UNITED STATES PATENT AND TRADEMARK OFFICE

APPLICATION NO.	FILING DATE	FIRST NAMED INVENTOR	ATTORNEY DOCKET NO.	CONFIRMATION NO.
10/688,303	10/15/2003	Kentaro Nagoshi	SIW-067	9456
959	7590	08/30/2006	EXAMINER	
LAHIVE & COCKFIELD 28 STATE STREET BOSTON, MA 02109			ALEJANDRO, RAYMOND	
			ART UNIT	PAPER NUMBER

Office Action Summary

DETAILED ACTION

【図 1】

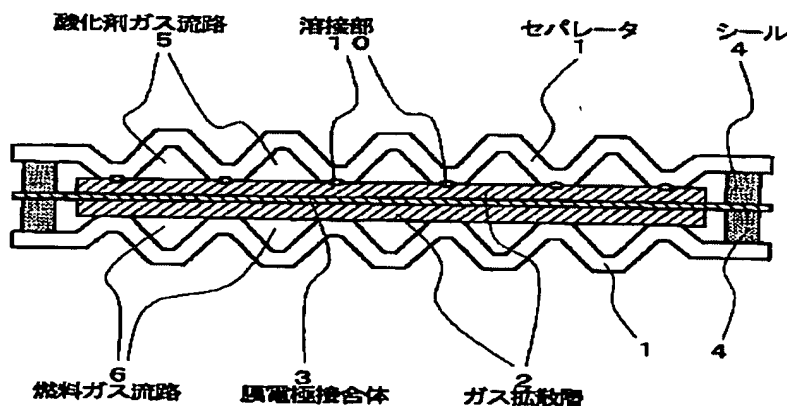
Both the gas diffusion layer and the metallic separator are bonded by resistance welding at a welding part 10. *Thus, they are welded together.*

Figure 1 below illustrates the gas diffusion layer 2 and the separator 1 adjacent to each other; the gas flow channels 5 and 6; and the welding parts 10.

As shown above in **Figure 1**, the combination of the corrugated separators 1 and the welding parts 10 allows the formation of reactant passages 5 and 6 (See Figure 1). *Note: the part connecting separator plate 1 and diffusion layer 2 clearly forms partitions in the diffusion layer; consequently, oxidizing gas or fuel pathways are formed. Additionally, welding part 10 formed in the diffusion layer is also part of the partition formed therein.*

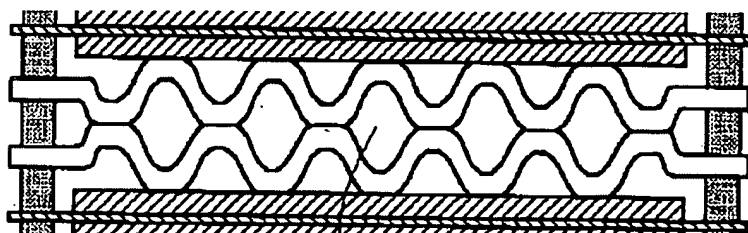
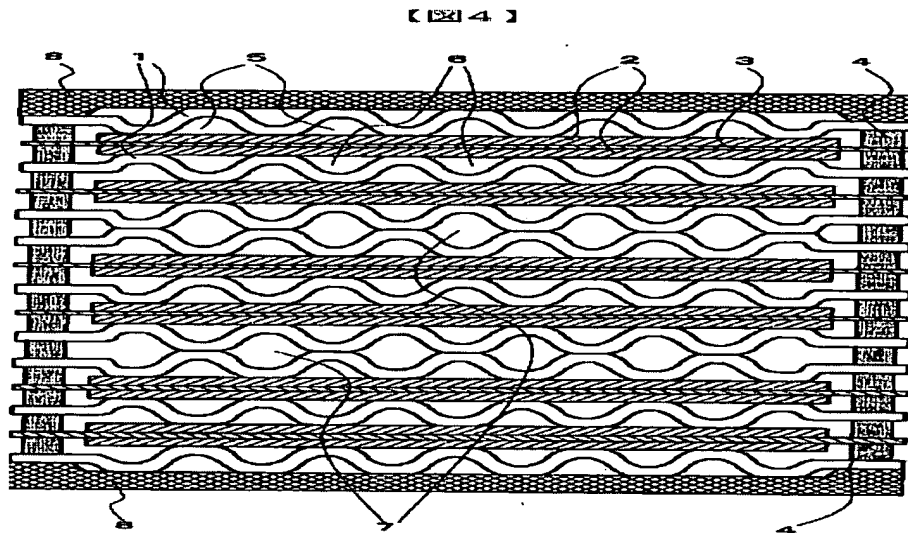
Figure 4 below of the JP'153 illustrates the inclusion of separator layers forming cooling water passages 7. *Note that such separator layers are joined together or bonded to form the cooling water passage structure. Enlarged portion of Figure 4 better illustrates this configuration.*

【図1】

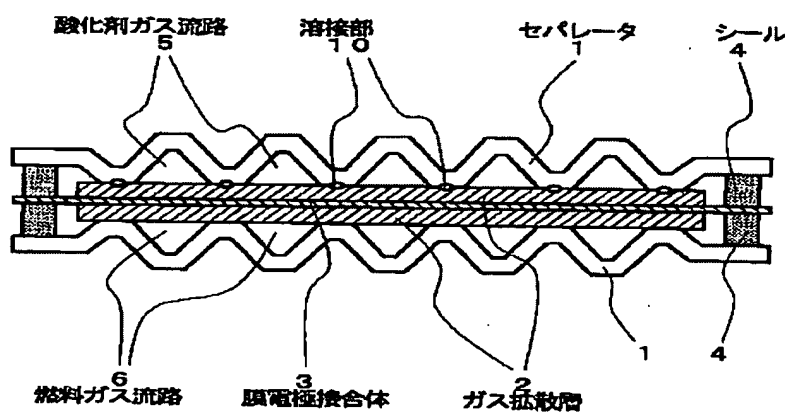
a flow passage for the fuel or oxidizer in the diffusion layer” in the JP’153, the examiner states that as shown above in **Figure 1**, the combination of the corrugated separators 1 and gas diffusion layers 2, and/or the welding parts 10 allows the formation of reactant passages 5 and 6 (See Figure 1). It is strenuously noted that the part connecting separator plate 1 and diffusion layer 2 clearly forms partitions in the diffusion layer; consequently, oxidizing gas or fuel passages 5 and 6 are formed. Additionally, welding part 10 formed in the diffusion layer is also part of the partition formed therein, and such a welding part can be taken as a partition by itself, or collectively with features 1 (separators) and 3 (gas diffusion layers). Clearly, **Figure 1** shows partitions forming both fuel and oxidizer gas flow passages.
